Access Compliance Report Public Rights-of-Way (RR Crossings)

Intersection ID: 12779	Main Street: E_TRADE_ST	Location: N/A
ADA ID: D2D445943C9A	Overall Compliance: No	Severity Score: 0.0
Codes/Mitigation Info/Possible Solution		Field Measurements/Component Compliance

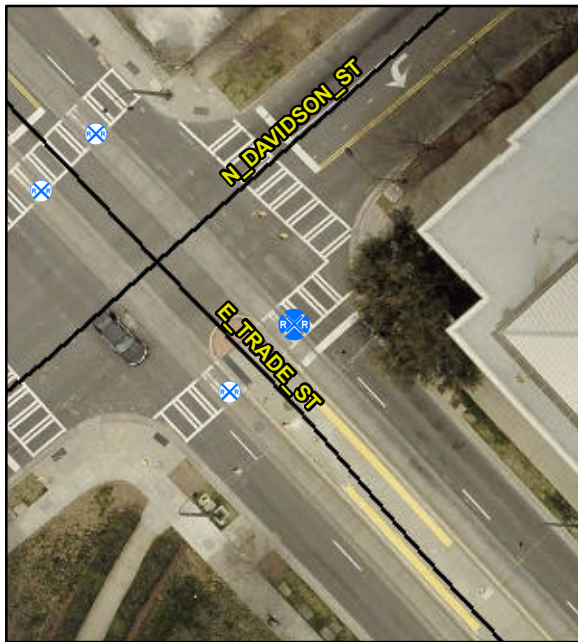
Remove & Replace Detectable Warning System. Provide Pedestrian Gate. Remove & Replace Walking Surface Adjacent to Rail.

LIGHTRAIL IN STREET WITH MEDIAN REFUGE ON ONE SIDE

R302.7.4, R305.2.5

Compliance	Description	Data
Yes	DWS Provided?	Yes
Yes	DWS Contrast?	Yes
Yes	DWS Width (in)	Yes
Yes	DWS Length (in)	25.0
No	DWS Offset (in)	25.0
No	Pedestrian Gate?	No
N/A	DWS Outside Gate?	No
N/A	Rail Type?	LightRail
No	Flangeway Gap (in)	2.5
Yes	Sidewalk Width (in)	113.0
